## AIRCRAFT AND MAINTENANCE PARTS

NORTH AMERICAN—INSPECTION AND REWORK OF ELEVATOR AND RUDDER  
FRONT BEAMS—P-51B, P-51C, P-51D, P-51K, F-6C, F-6D, AND F-6K

Figure 1 - General View - Elevator Tip

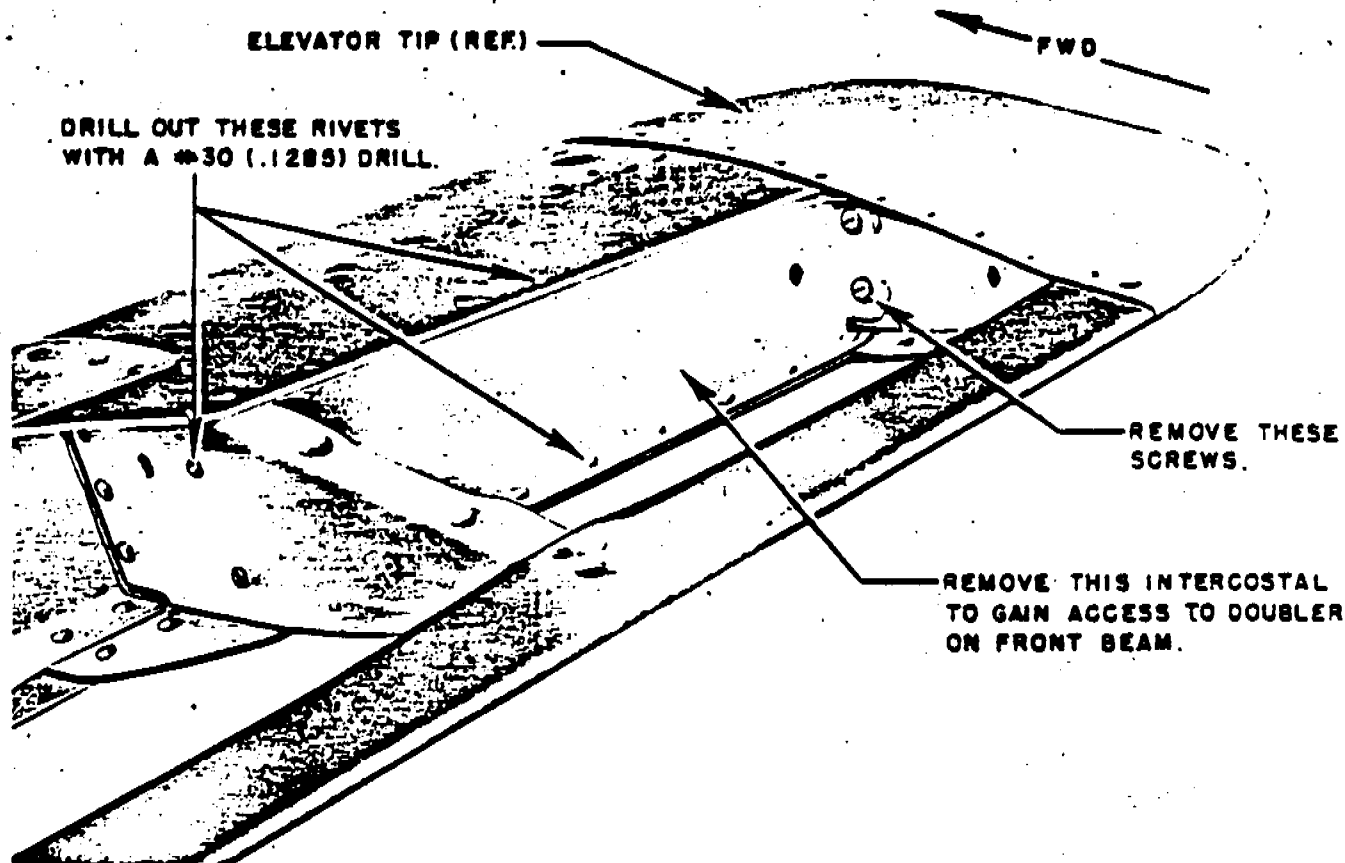
(3) Remove the intercostal from between the first and second ribs at the tip of the elevator. Drill out the rivets securing the intercostal with a No. 30 (.1285-inch) drill. (See figure 1.)

Figure 2 - Looking at Elevator Front Beam

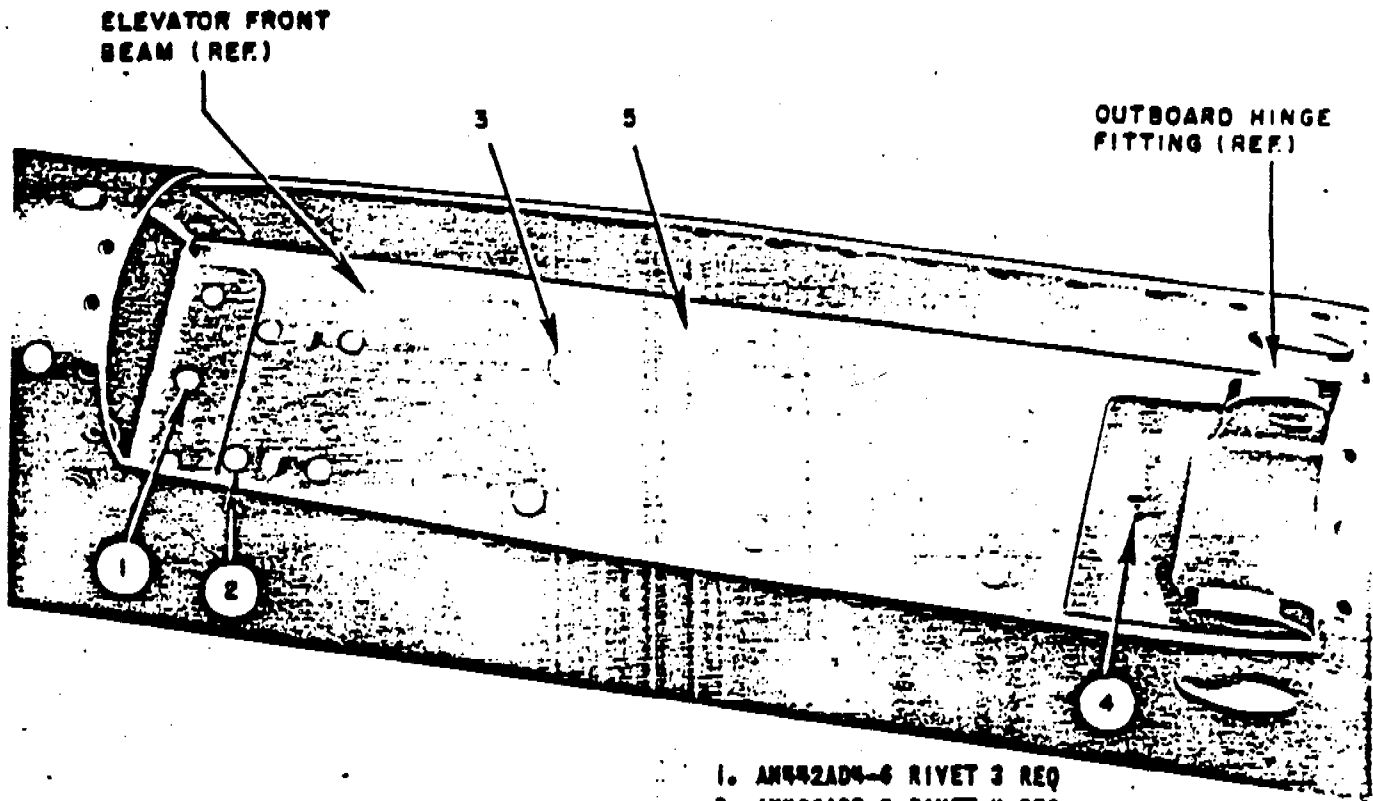
1. AN442AD4-6 RIVET 3 REQ
2. AN426AD3-4 RIVET 4 REQ
3. AN426AD4-4 RIVET 8 REQ
4. AN426AD3-6 RIVET 2 REQ TO SECURE NUT PLATE UNDER THIS HOLE. AN426AD3-6 RIVET 4 REQ. TO SECURE OTHER TWO NUT PLATES UNDER BRACKET.
5. REMOVE OLD DOUBLER FROM AFT SIDE OF BEAM. FABRICATE NEW .040 DOUBLER 9-9/16 IN. LONG FROM ALUM.-ALLOY SHEET. NEW DOUBLER TO BE FLANGED AS OLD DOUBLER AND WILL EXTEND TO OUTBOARD END OF BEAM.

(5) Drill out the rivets securing the nut plates to the back of the beam and doubler. Use a No. 40 (.098-inch) drill. There are five such nut plates. (See figure 2.)

(6) Drill out the rivets securing the doubler to the aft side of the beam. Use a No. 30 (.1285-inch) drill. There are 11 such rivets. (See figure 2.) Also drill out the rivets securing the doubler flanges to upper and lower surface of elevator.

(9) Secure the new doubler to the aft side of the beam at these holes using eight rivets, part No. AN426AD4-4, and three rivets, part No. AN442AD4-6 (See figure 2.)

(7) Remove the doubler from the aft side of the beam. Fabricate a new doubler from aluminum-alloy sheet .040 x 4-1/2 (all bend radii to be 3/32 minimum) identical to the one just removed except that it shall be 9-9/16 inches long. Flange the top and bottom just as on old doubler. Joggle each end of both flanges so that the doubler will fit on aft side of beam. The additional length of the new doubler will extend it to the outboard end of the beam.

Figure 3 - Top View - Elevator Tip

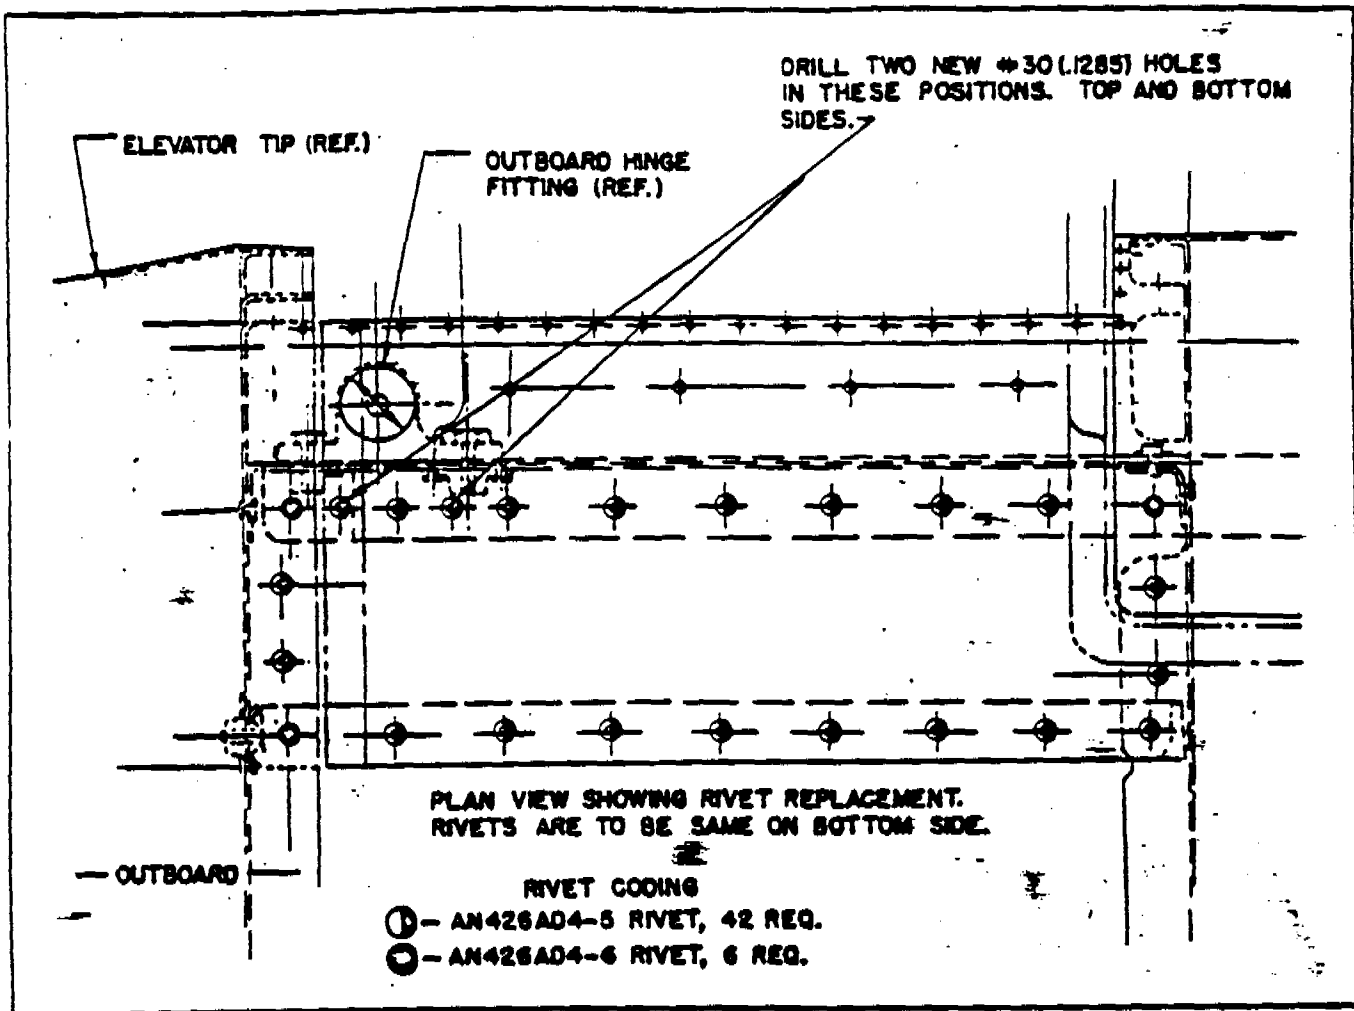
(13) Drill the rivet holes through the upper and lower flanges of the doubler with a No. 30 (.1285-inch) drill. Use the holes in the upper and lower surface of the elevator as templates. Secure the doubler at these holes with rivets as shown in figure 3.

(14) Reinstall the intercostal using rivets as shown in figure 3.

Figure 4 - General View - Rudder Tip

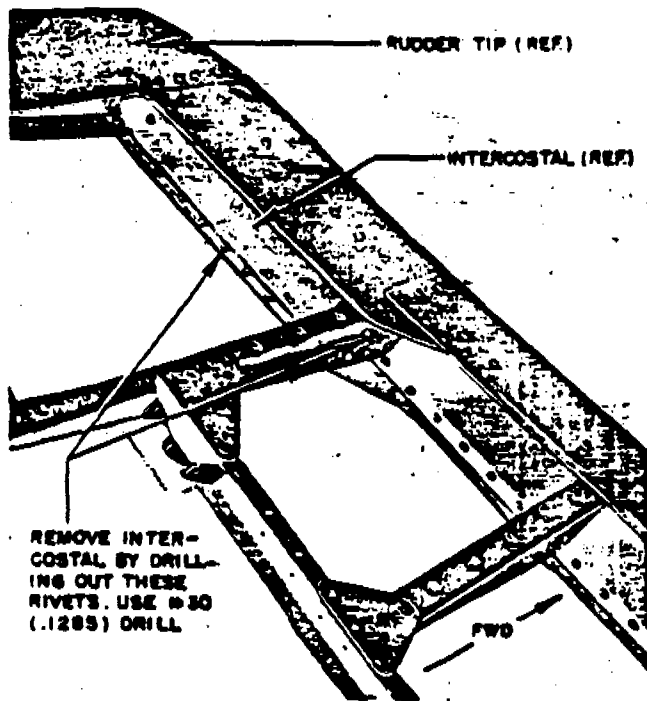
(3) Remove the intercostal from between the first and second ribs at the tip of the rudder. Drill out the rivets securing the intercostal with a No. 30 (.1285-inch) drill. (See figure 4.)

Figure 5 - Looking at Rudder Front Beam

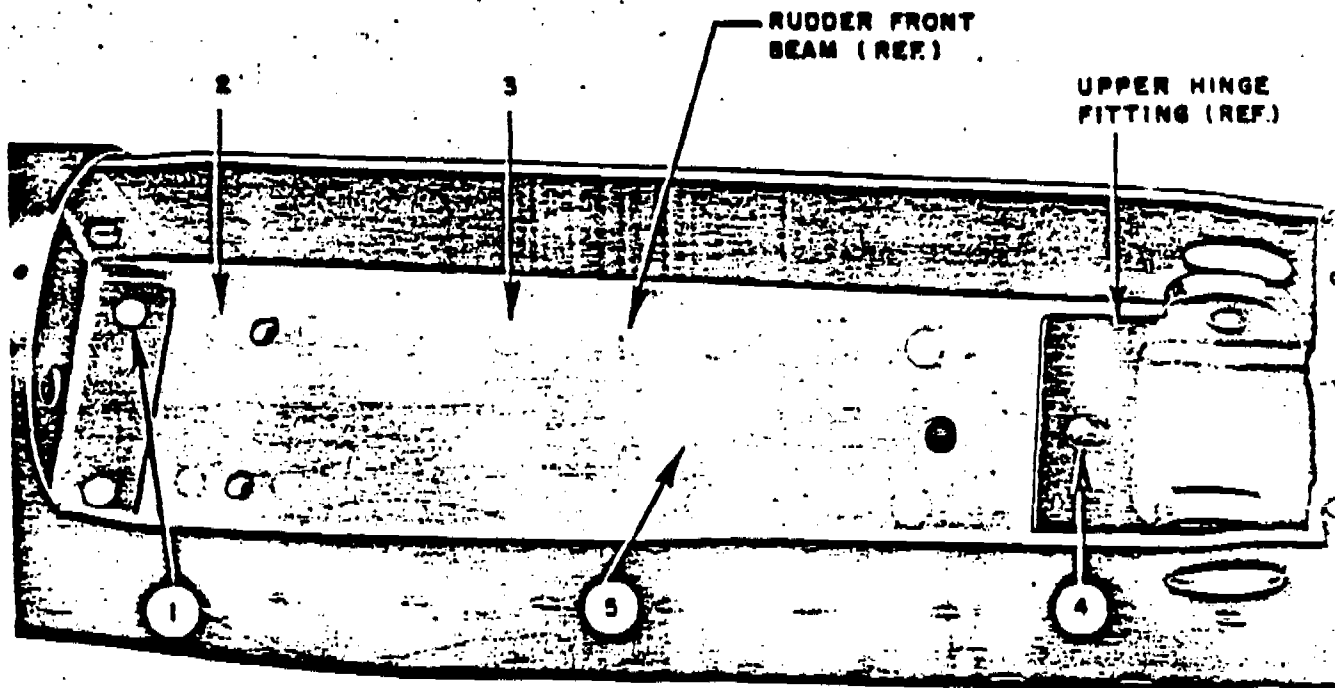
(5) Drill out the rivets securing the nut plate to the back of the beam and doubler. Use a No. 4 (.098-inch) drill. There are five such nut plates. (See figure 5.)

1. AN42A04-6 RIVET 2 REQ
2. AN42A03-4 RIVET 4 REQ
3. AN42A04-4 RIVET 8 REQ
4. AN42A03-6 RIVET 6 REQ TO SECURE NUT PLATES.
5. REMOVE OLD DOUBLER FROM AFT SIDE OF BEAM. FABRICATE NEW .040 DOUBLER 9-1/8 IN. LONG FROM ALUM.-ALLOY SHEET. NEW DOUBLER TO BE FLANGED AS OLD DOUBLER AND WILL EXTEND TO UPPER END OF BEAM.

(6) Drill out all rivets securing the doubler to the aft side of the beam. (See figure 5.) Use a No. 30 (.1285-inch) drill. Drill out all rivets securing the doubler and beam flanges to the left and right surfaces of the rudder.

AN426AD4-4, and two rivets, part No. AN442AD4-6. (See figure 5.)

(7) Remove the doubler from the aft side of the beam. Fabricate a new doubler from aluminum-alloy sheet .040 x 4 inches (all bend radii to be 3/32 minimum) identical to the one just removed except that it shall be 9-1/8 inches long. Flange both sides just as on the old doubler. Joggle each end of both flanges so that the doubler will fit on the aft side of the beam. The additional length of the new doubler will extend it to the upper end of the beam.

Figure 6 - Plan View - Rudder Tip

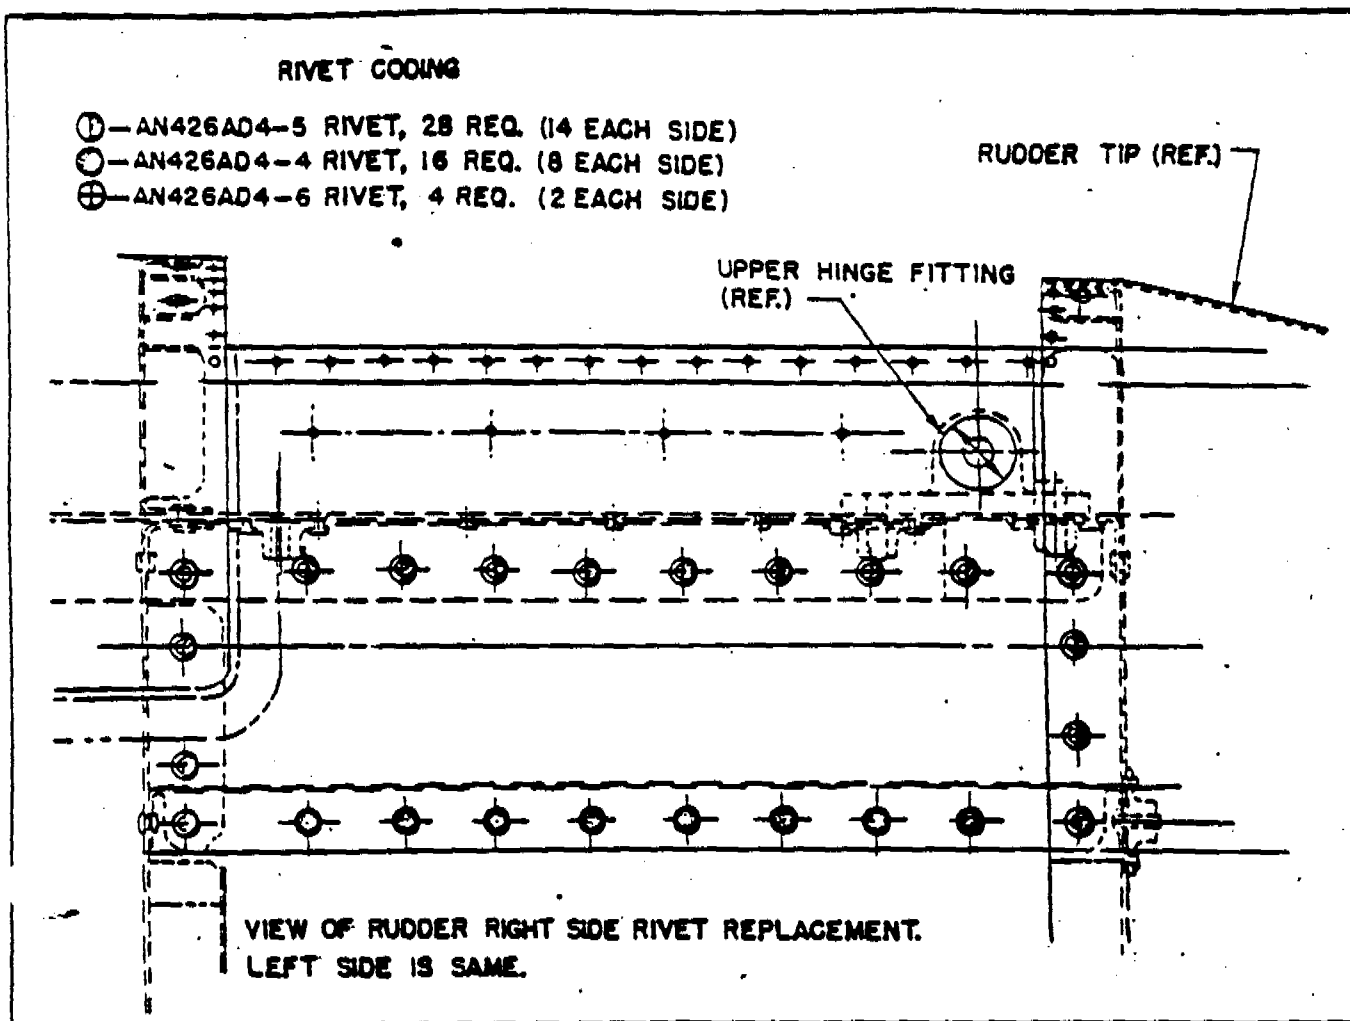
(13) Drill the rivet holes through the left and right flanges of the doubler with a No. 30 (.1285-inch) drill. Use the holes in the left and right surfaces of the rudder as templates. Secure the doubler at these holes with rivets as shown in figure 6.

(14) Reinstall the intercostal using rivets as shown in figure 6.
